Agenda
Village of Arlington Heights
Design Commission
Community Room, 3rd Floor

Arlington Heights Village Hall
33 S. Arlington Heights Road
Arlington Heights, IL 60005
December 11, 2018
6:30 PM

MINUTES OF
THE VILLAGE OF ARLINGTON HEIGHTS
DESIGN COMMISSION MEETING
HELD AT THE ARLINGTON HEIGHTS MUNICIPAL BUILDING
33 S. ARLINGTON HEIGHTS RD.
NOVEMBER 27, 2018

EXTERIOR ELEVATIONS, MATERIALS
LEGEND, DAYLIGHT PLANE

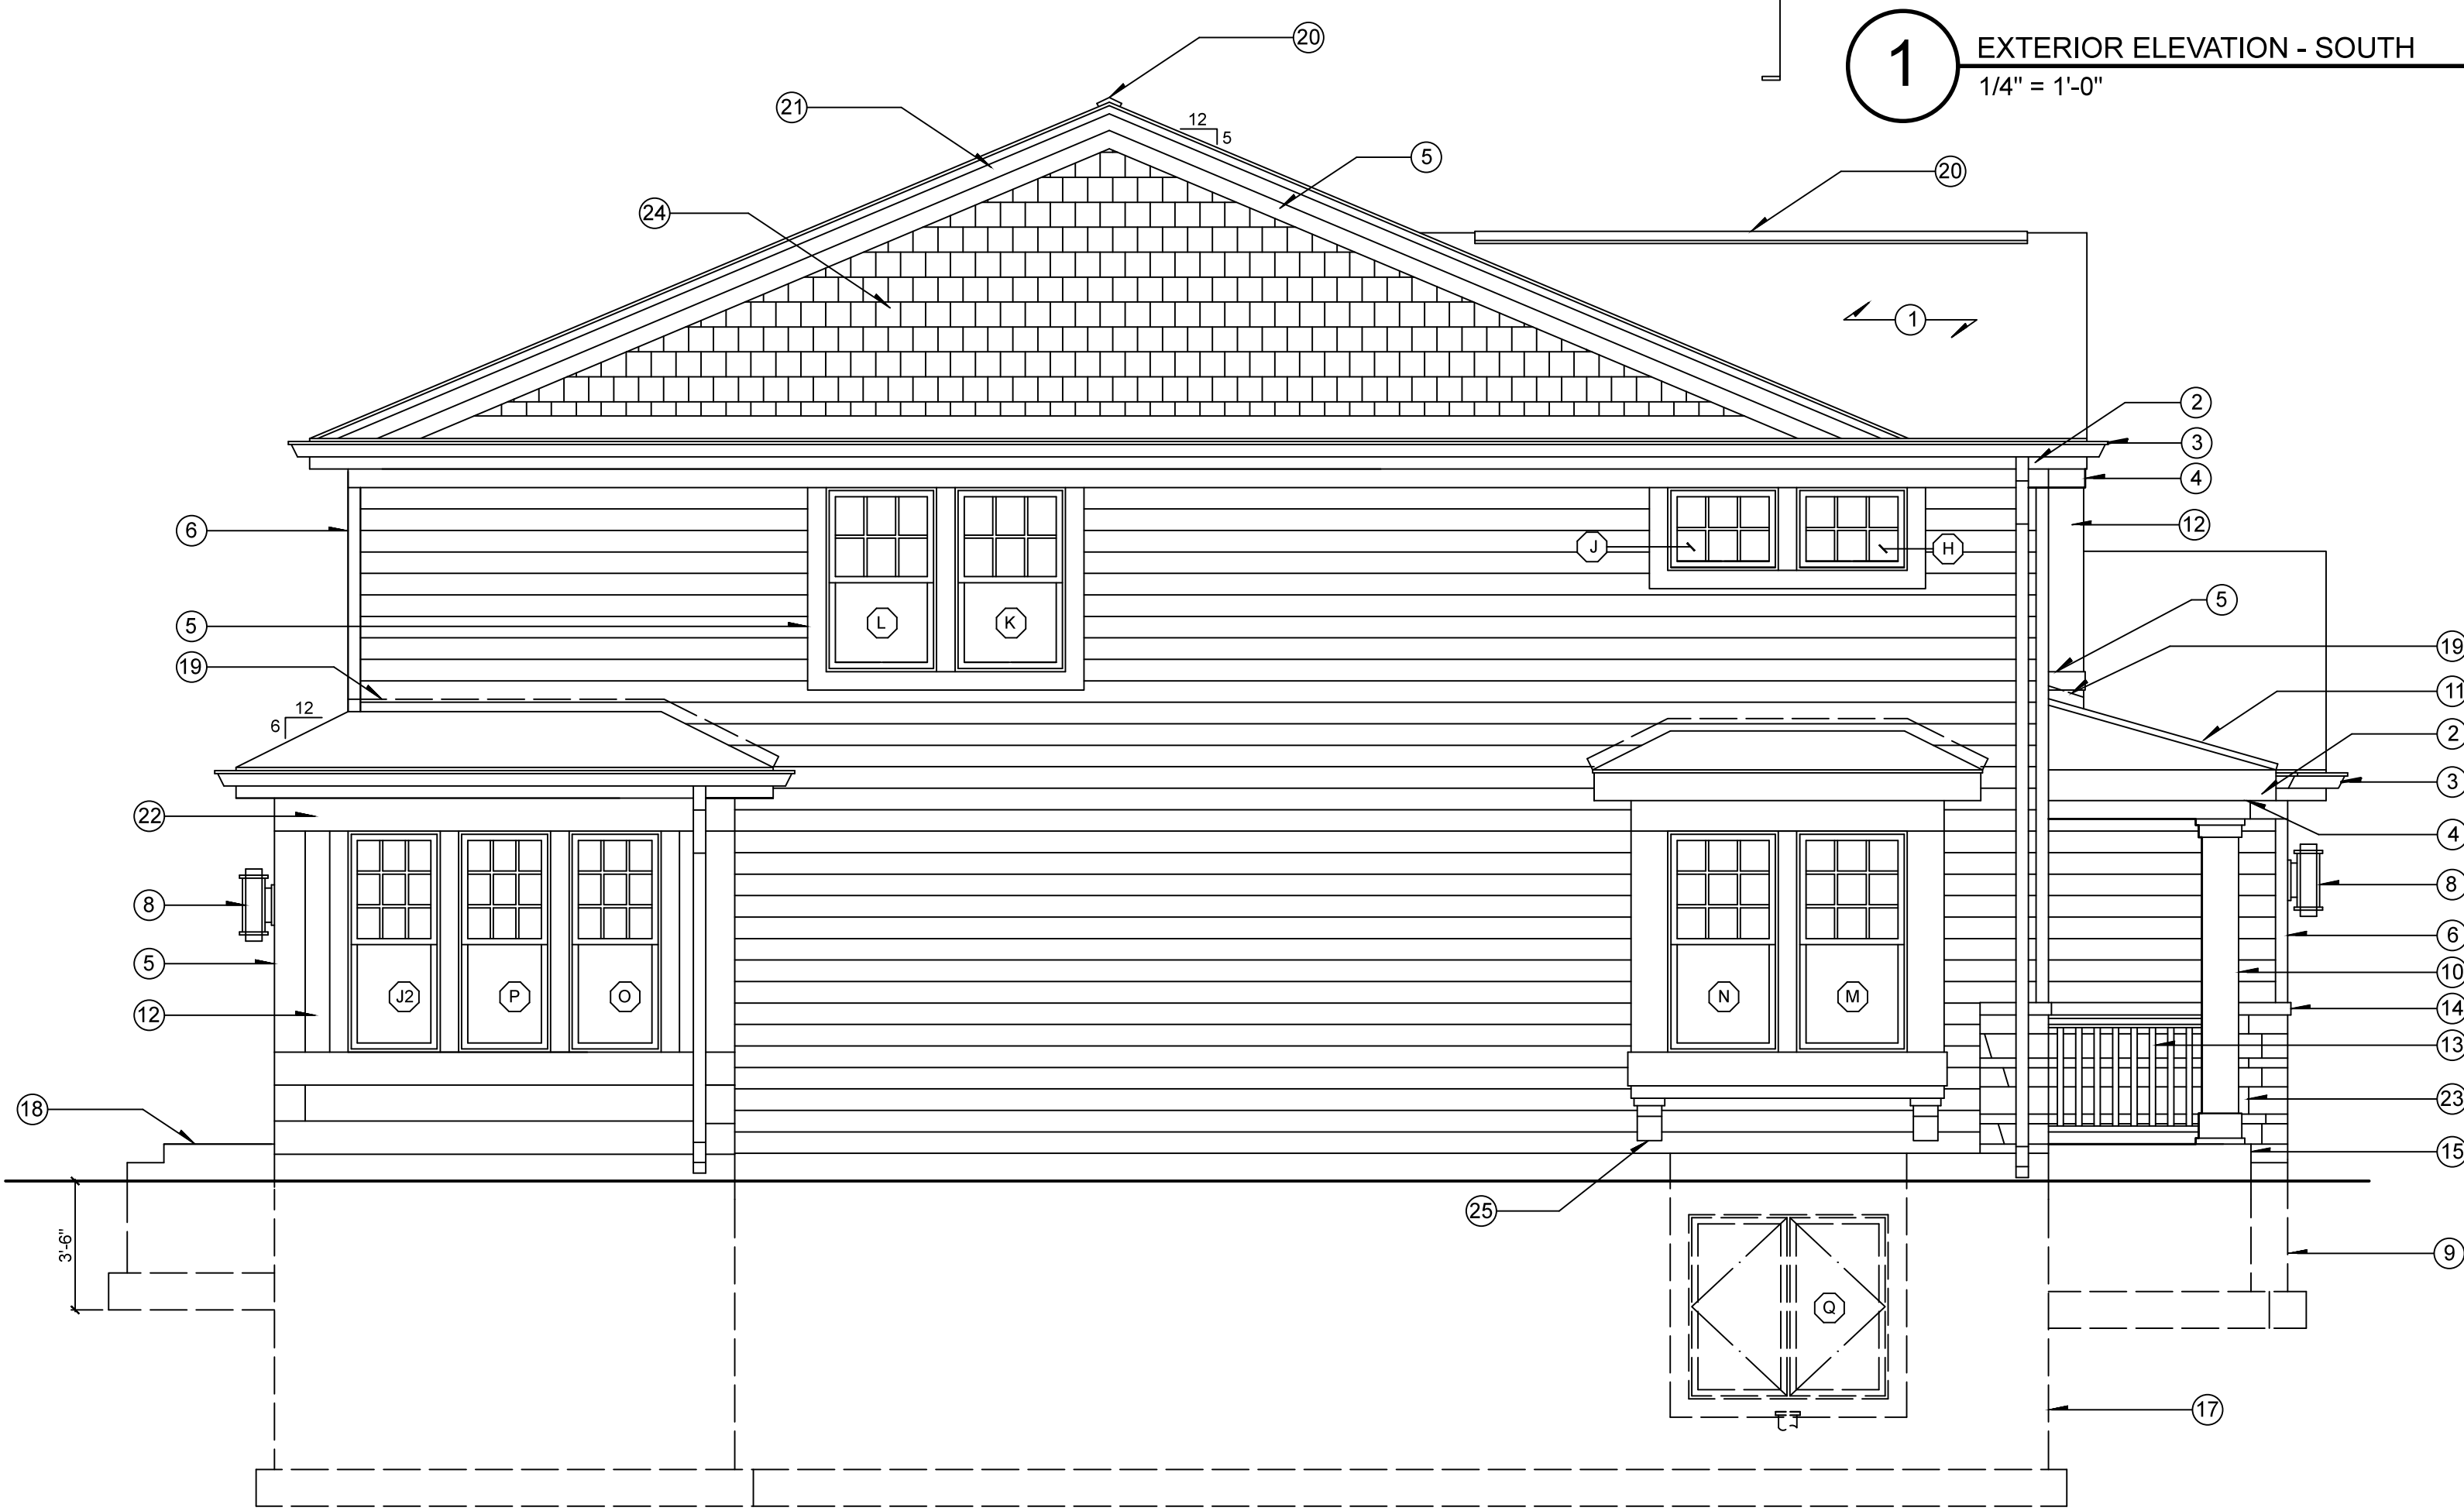
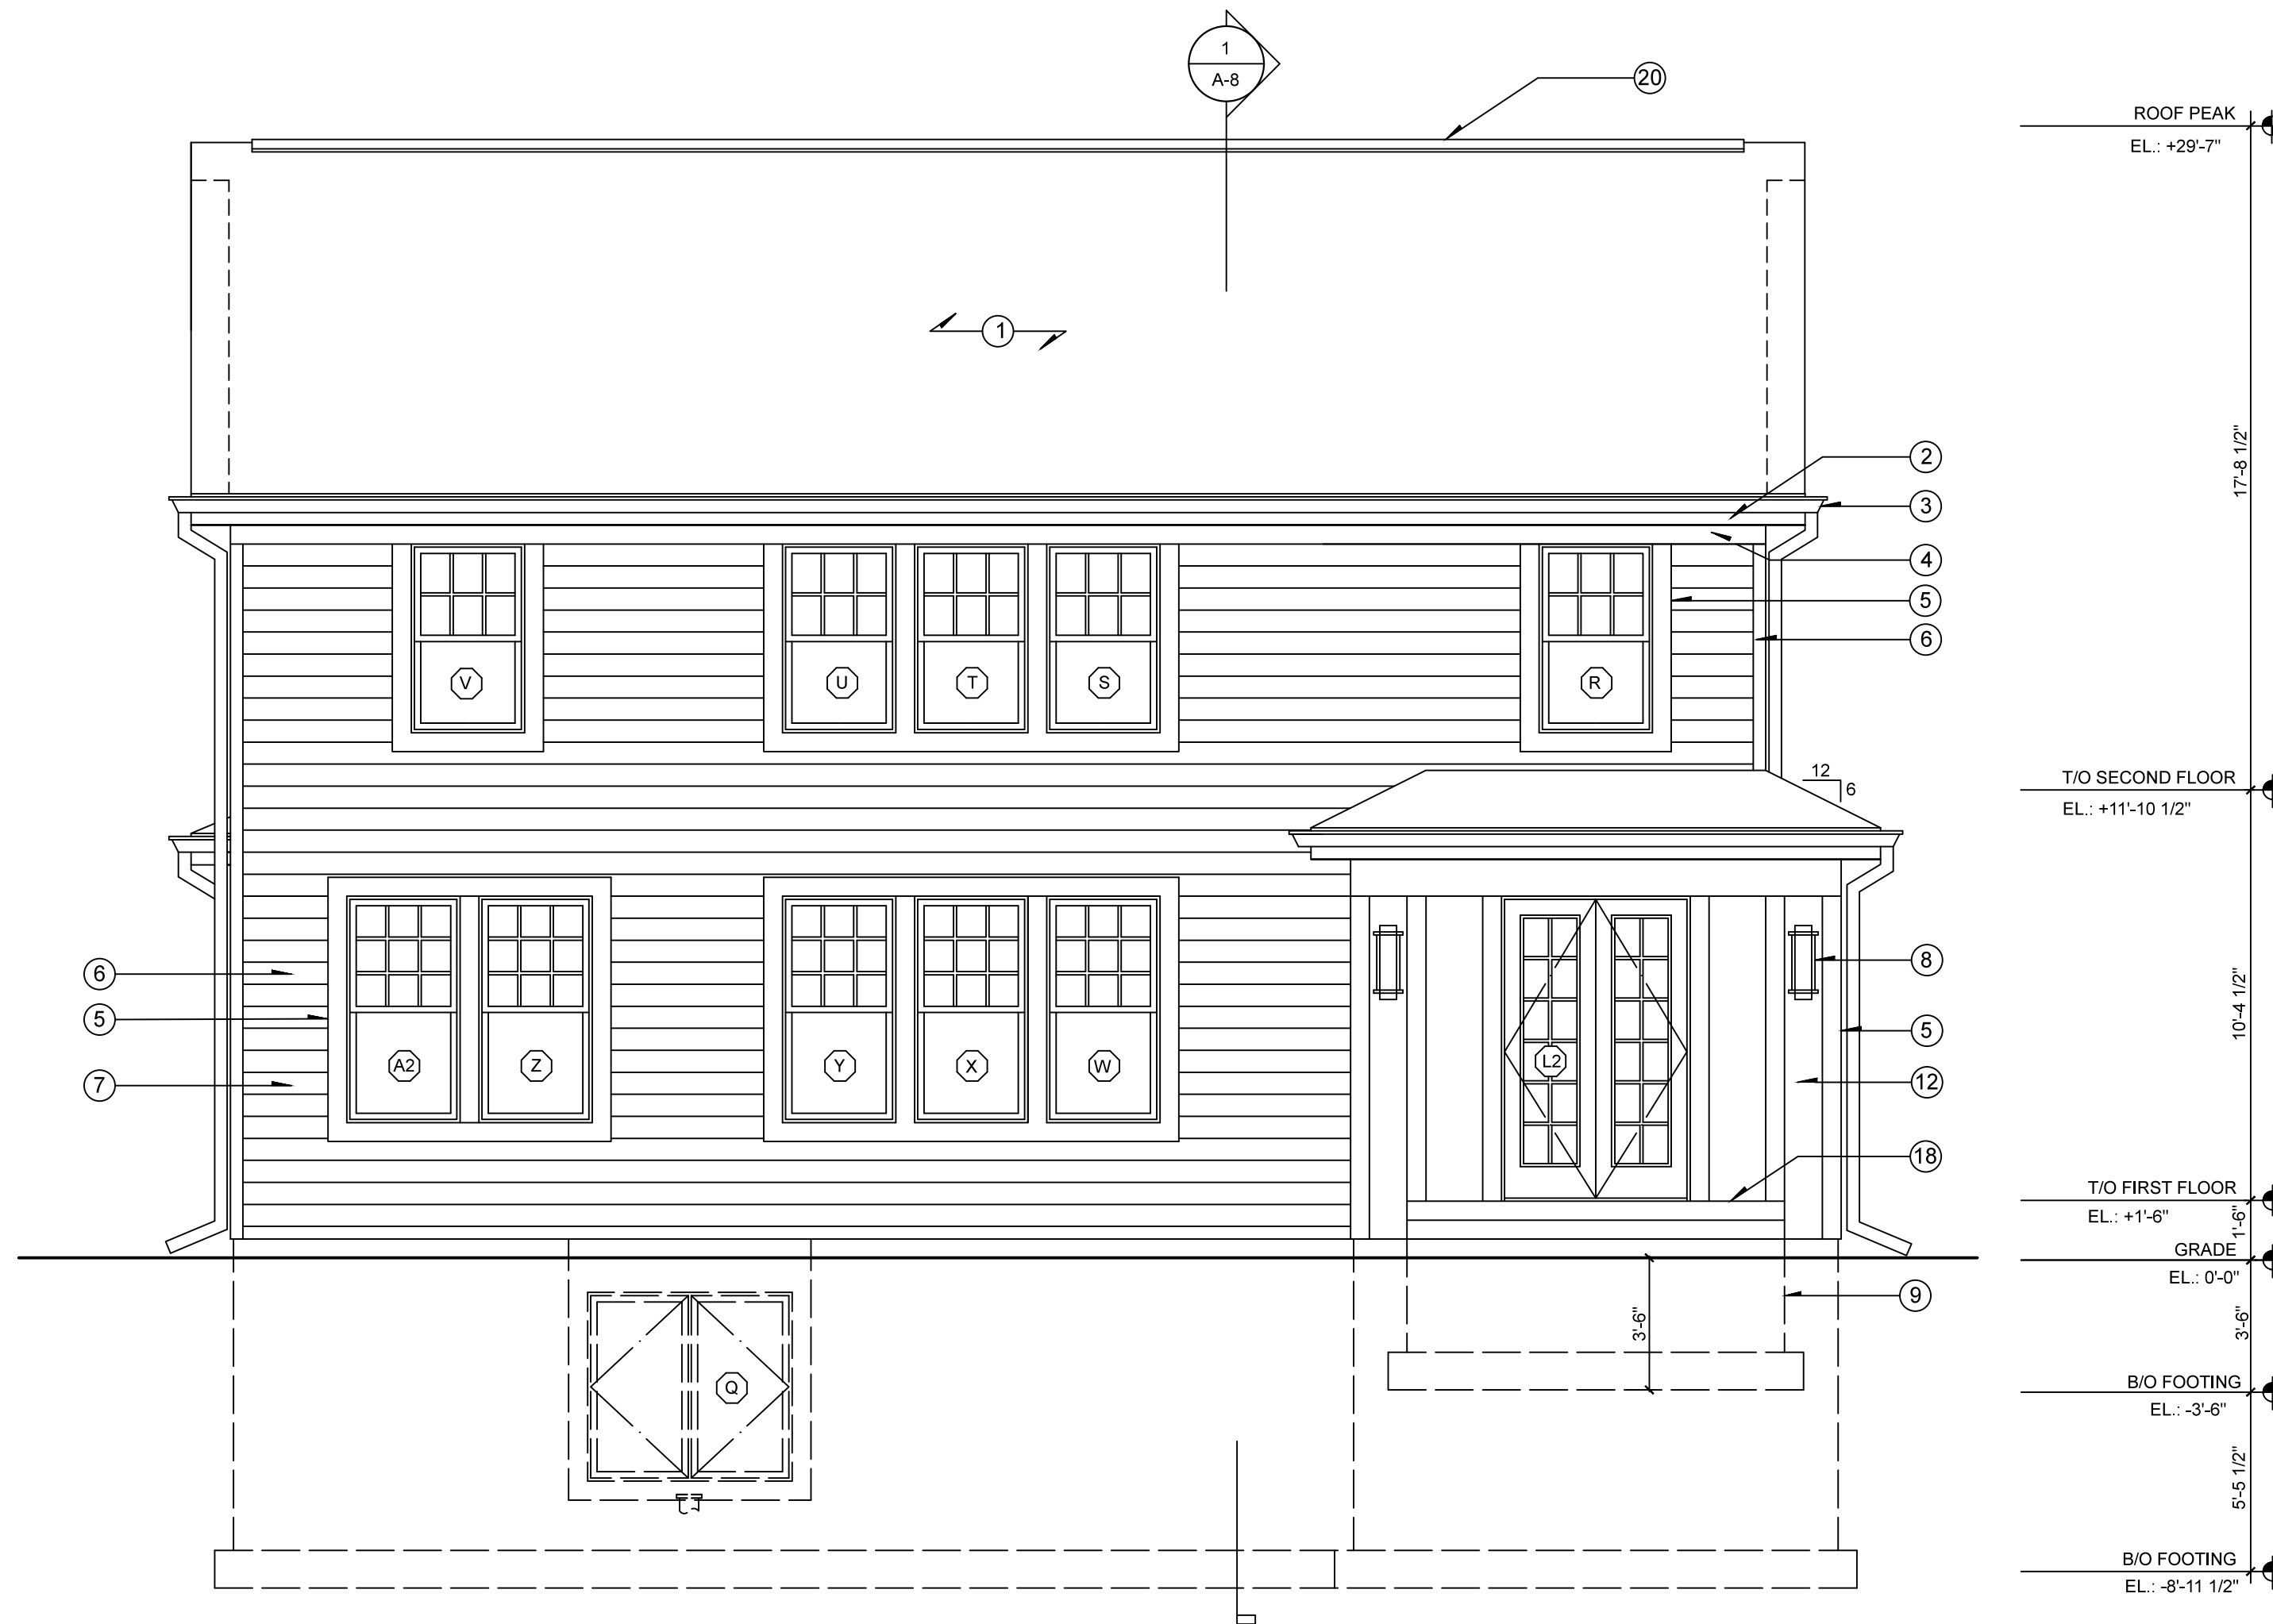
Overall, the proposed design is nicely done and is consistent with other newer homes approved in this neighborhood. Features such as the single-story front porch and single-story garage roof help the design to fit in with the adjacent single-story homes. The low-pitched gables fit well with the low-pitched roofs on the adjacent homes. The only comment on the design is that the proposed gray mist siding color is quite bright and cool as compared to the color tones of the other houses on the street. Consider a warmer gray siding color to better fit with the character of the neighborhood.

It is recommended that the Design Commission approve the proposed new single-family residence to be located at 534 W. Ridge Court. This recommendation is subject to compliance with the plans received on 11/8/18, and the following:
